ADDENDUM

May 15, 2020

RFB NO. 320012 - ADDENDUM NO. 1

**DANE COUNTY JAIL CONSOLIDATION
COURTHOUSE ELECTRICAL VAULT RELOCATION**

DO NOT SCALE DRAWINGS
SHEET CONTENTS
PROPOSED UTILITIES DEMOLITION PLAN

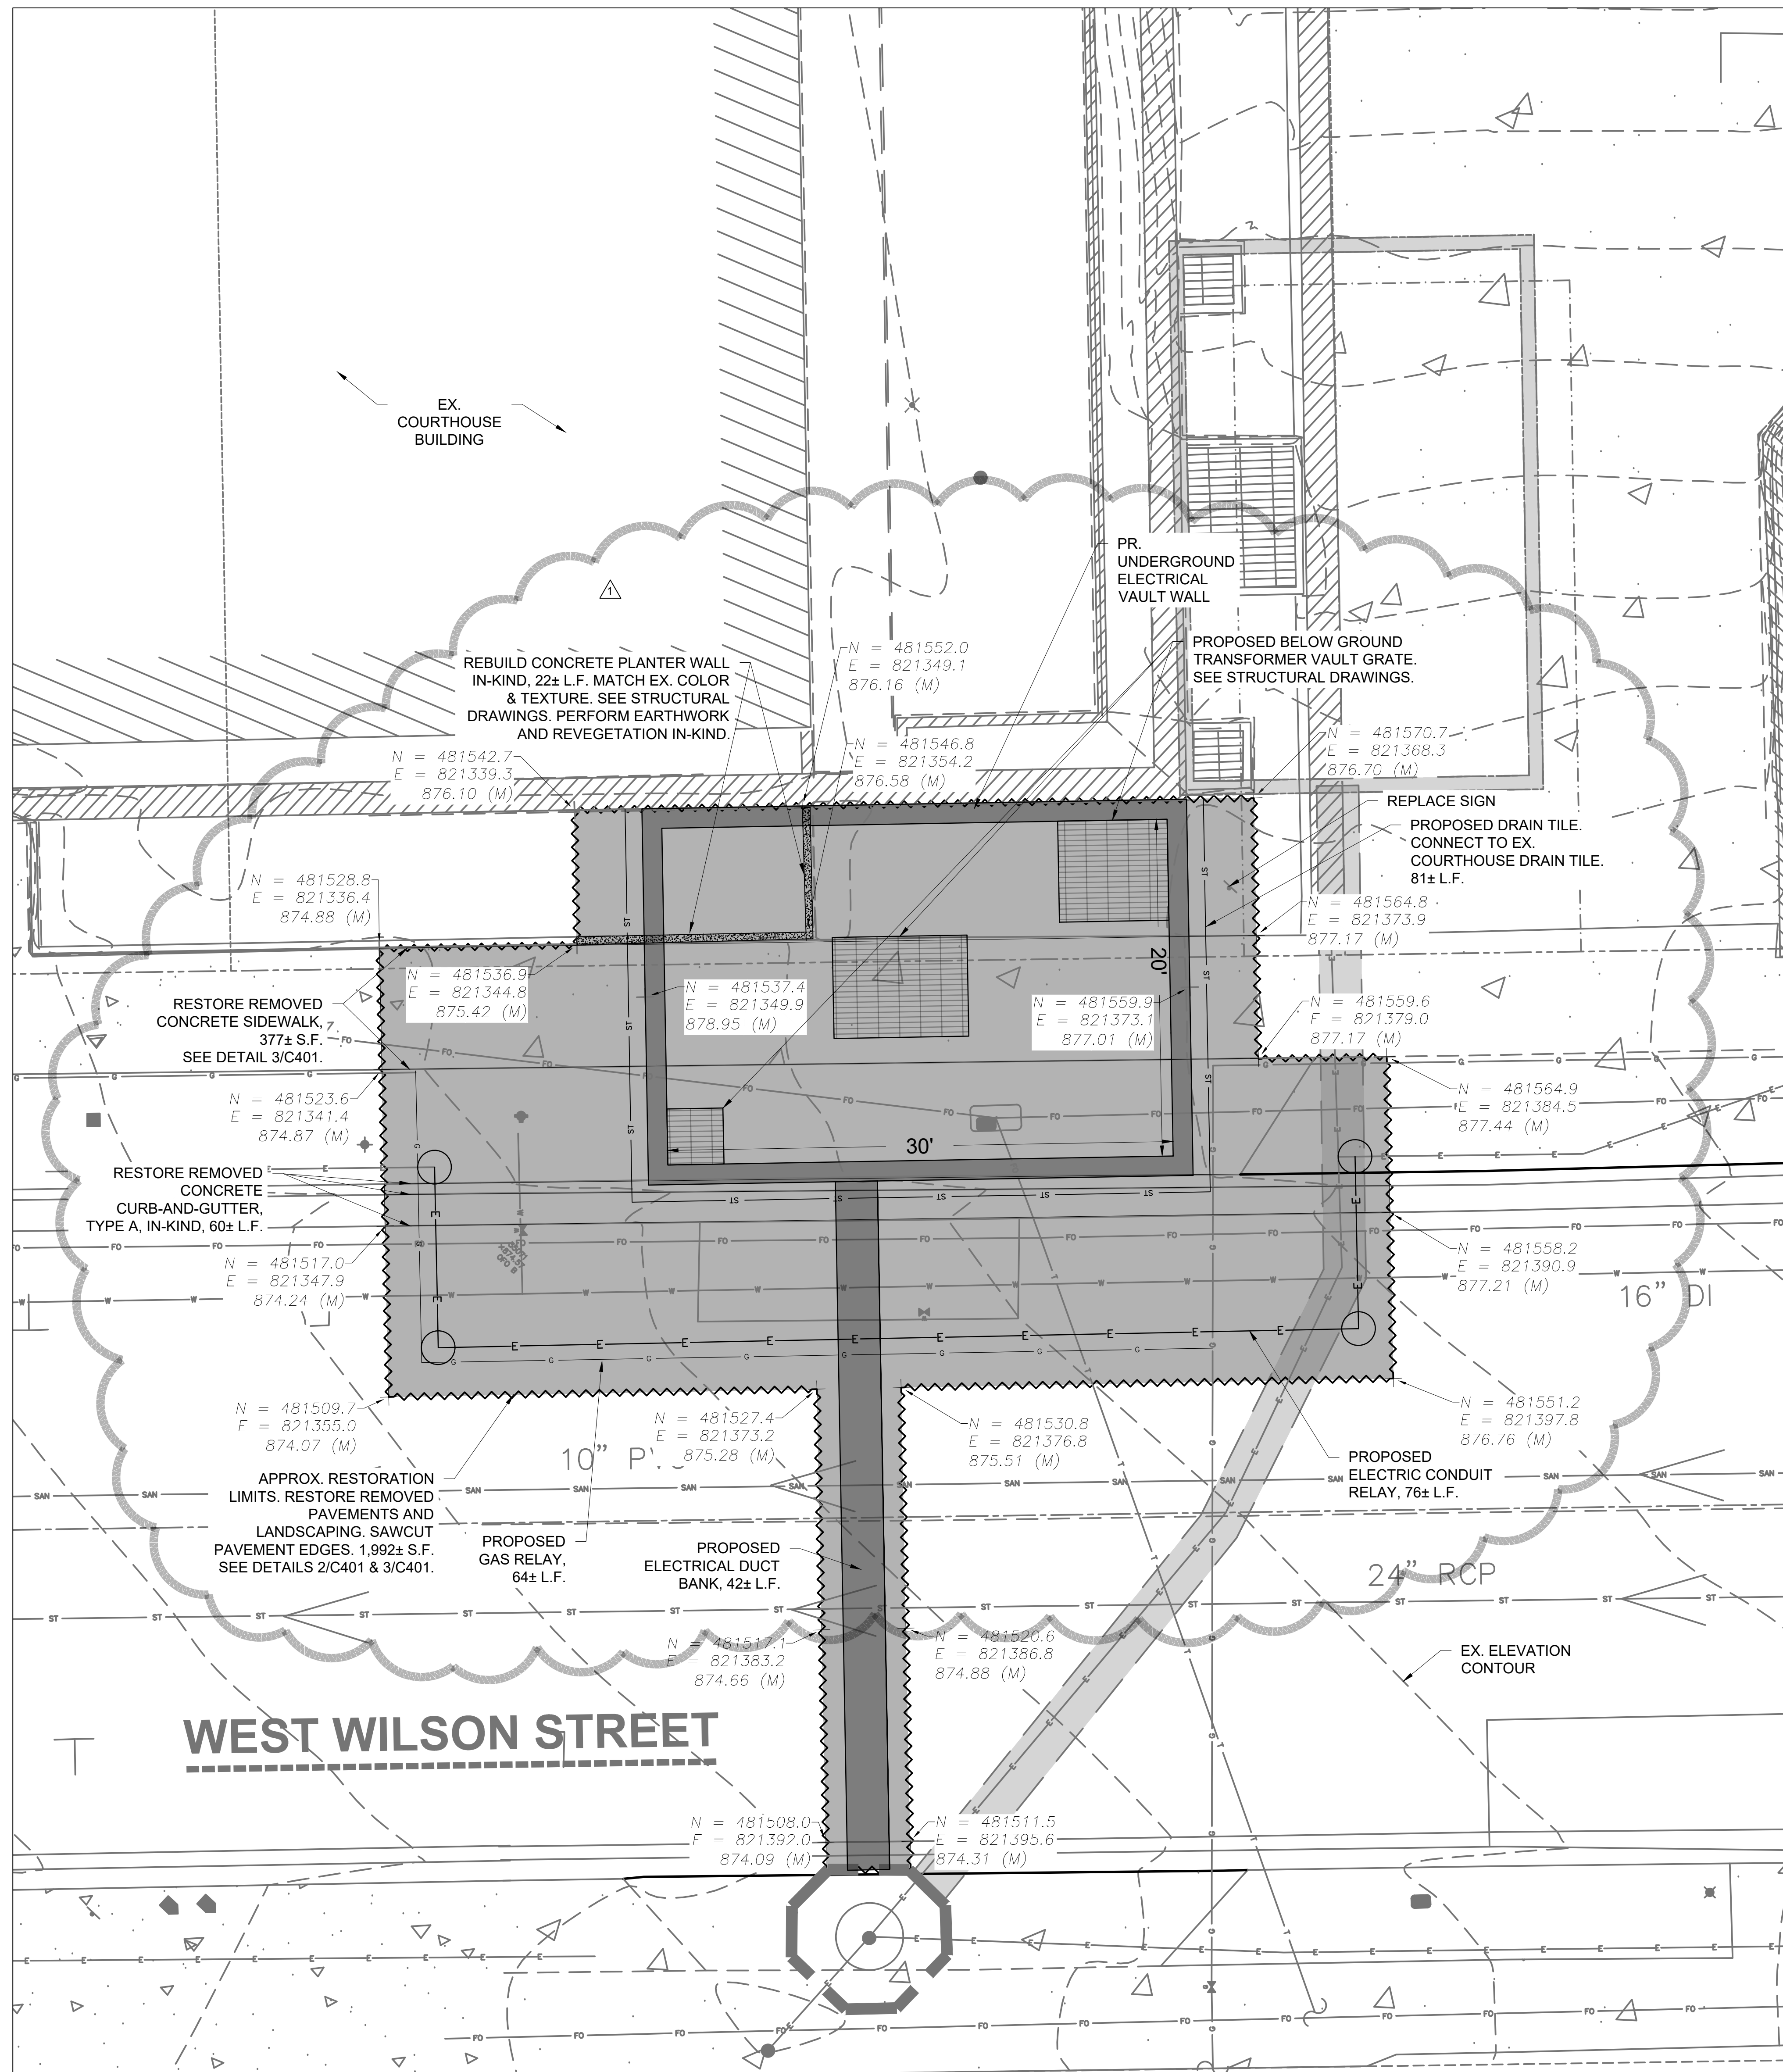
1. Moved proposed demolition limits to align with new vault location.
2. Moved proposed shoring limits to align with new vault location.

3
C401 TYPICAL PAVEMENT CROSS-SECTIONS
NTS

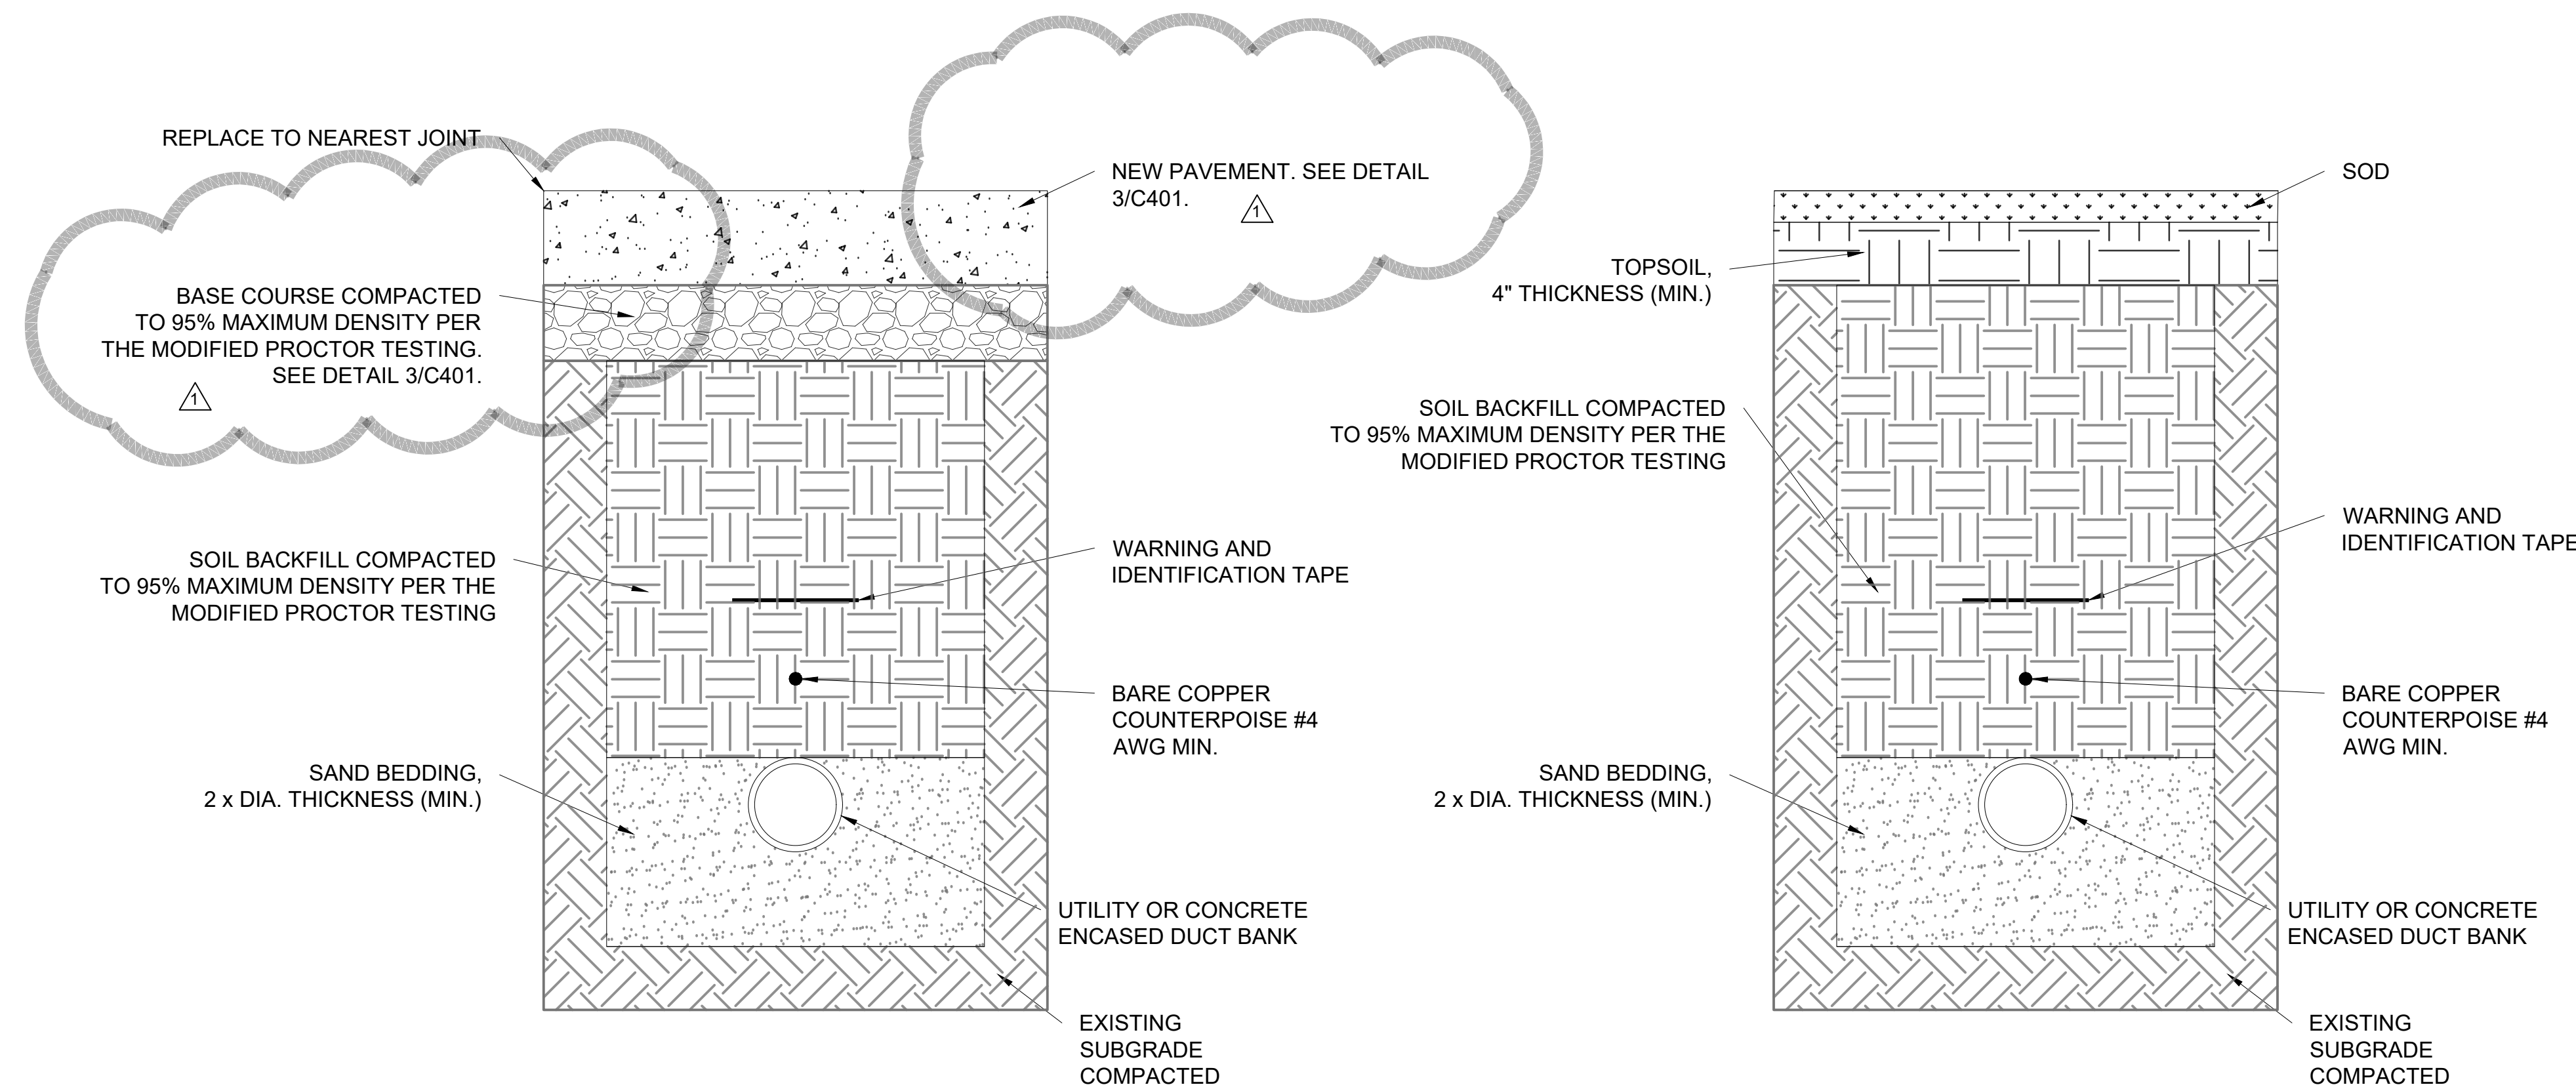
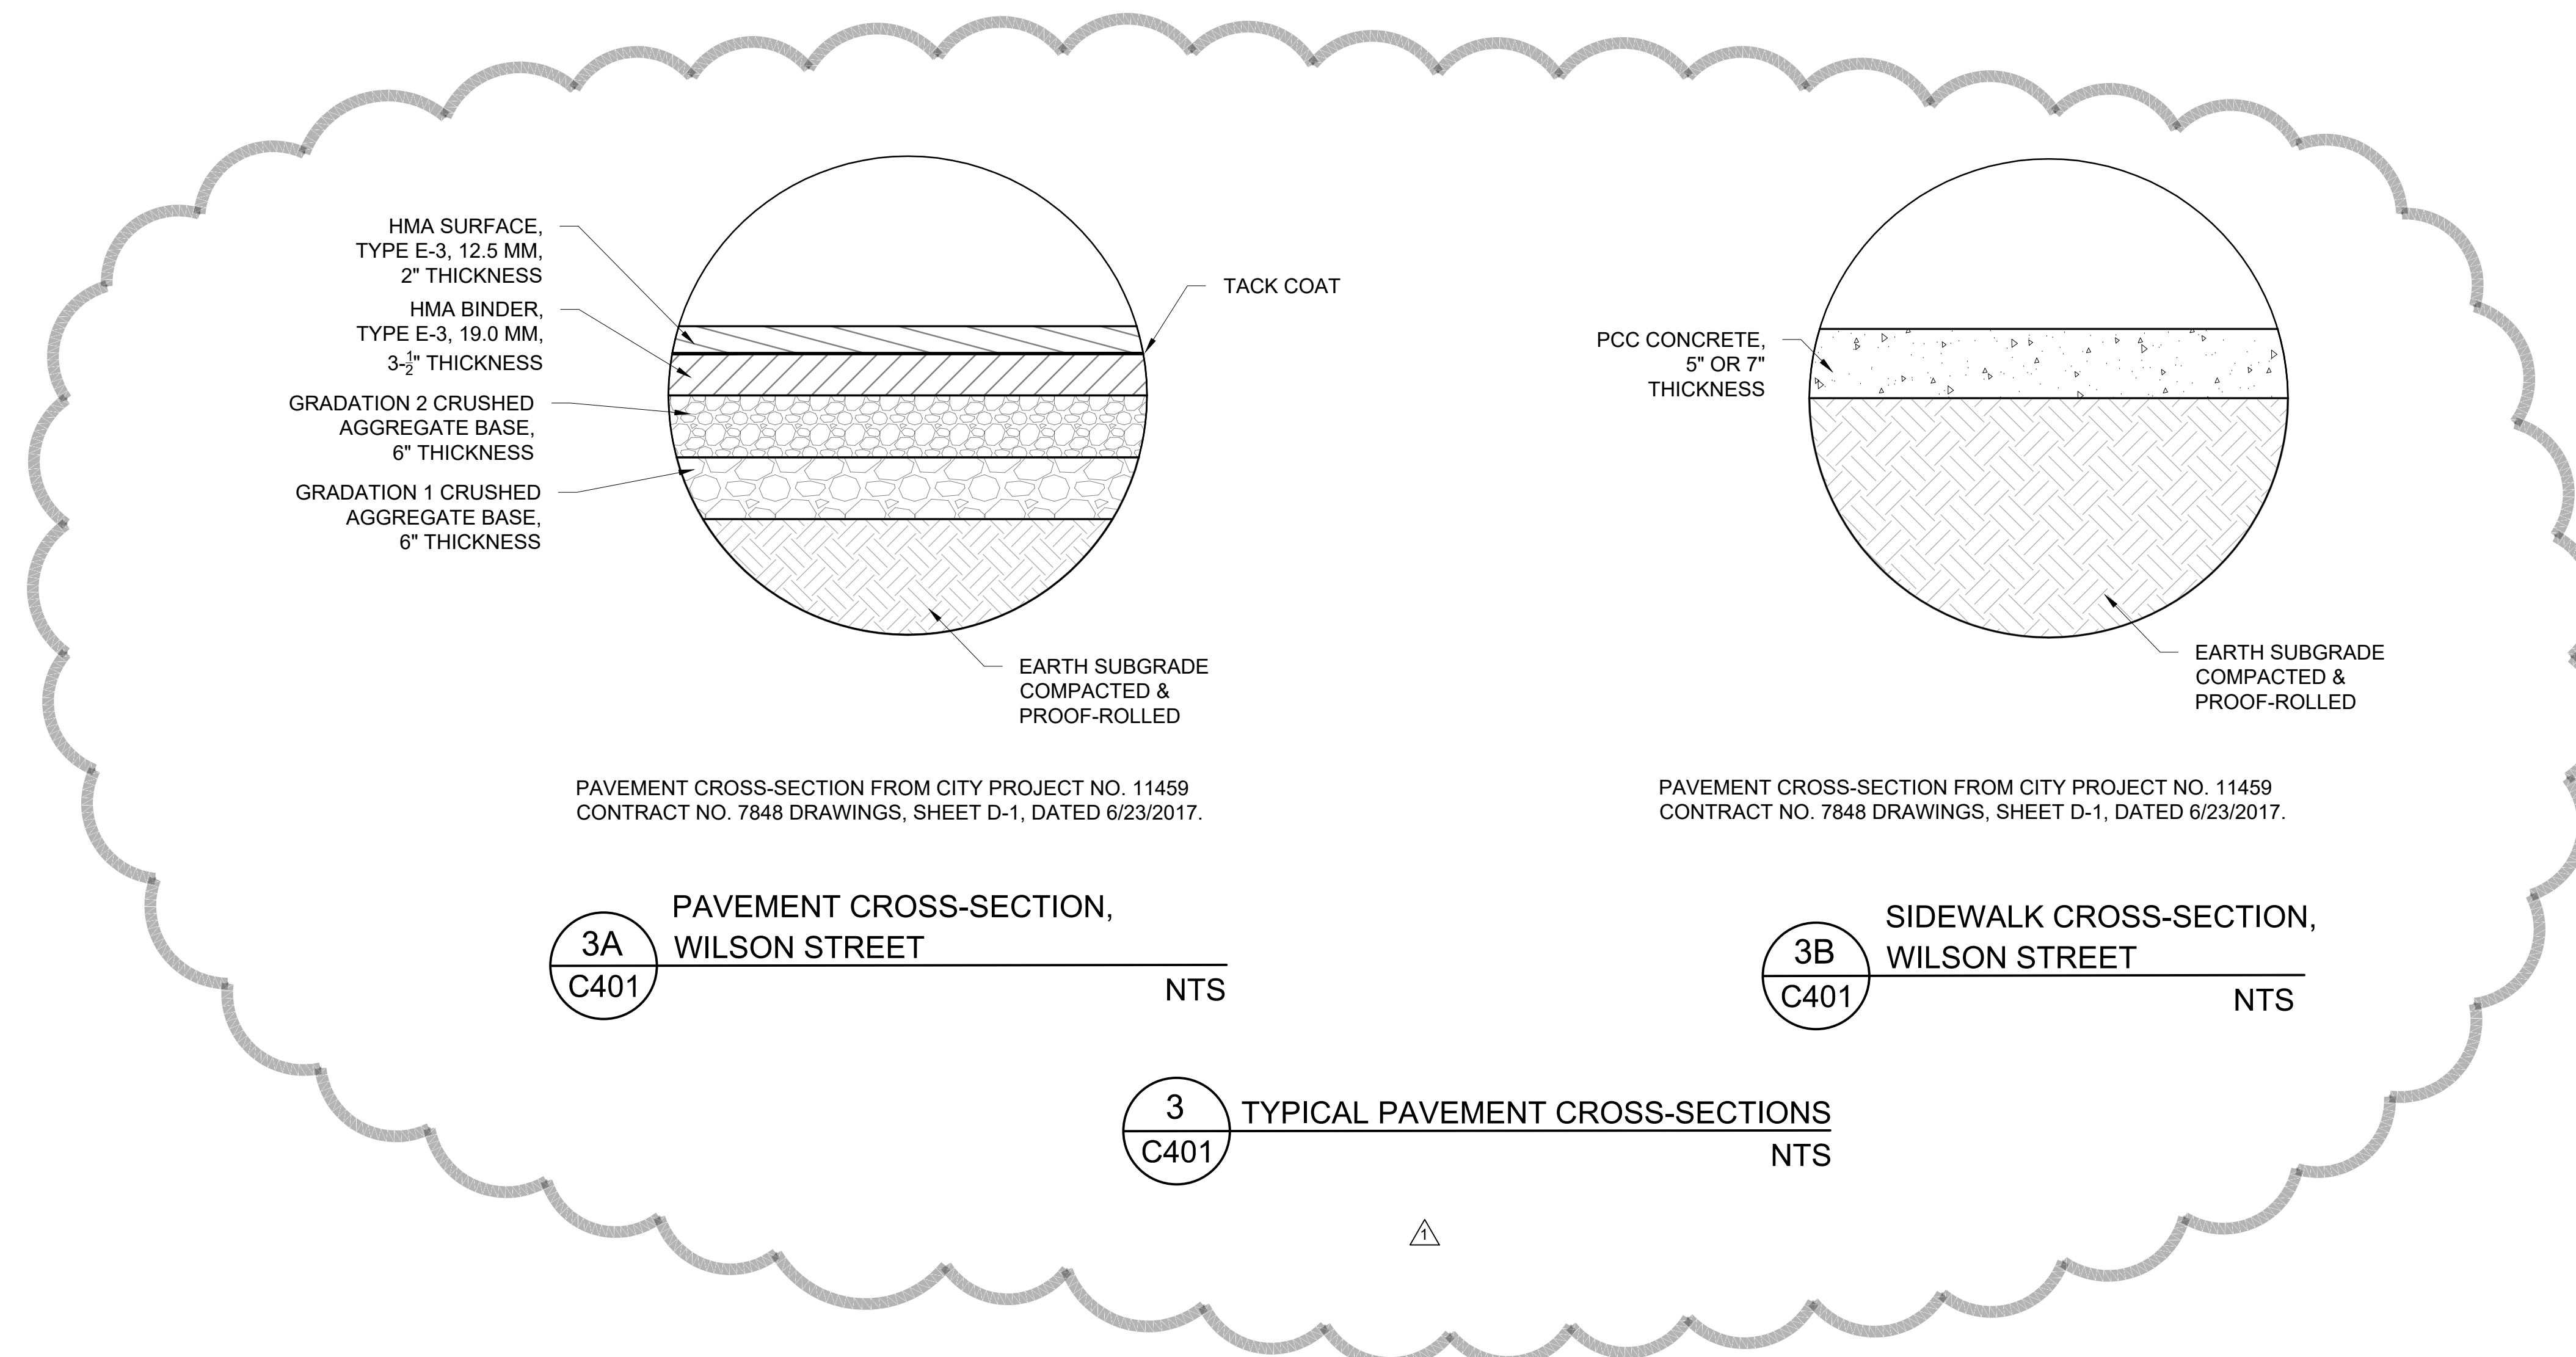
1. Added Detail 3/C401
2. Added References to Detail 3/C401 in Detail 2/C401
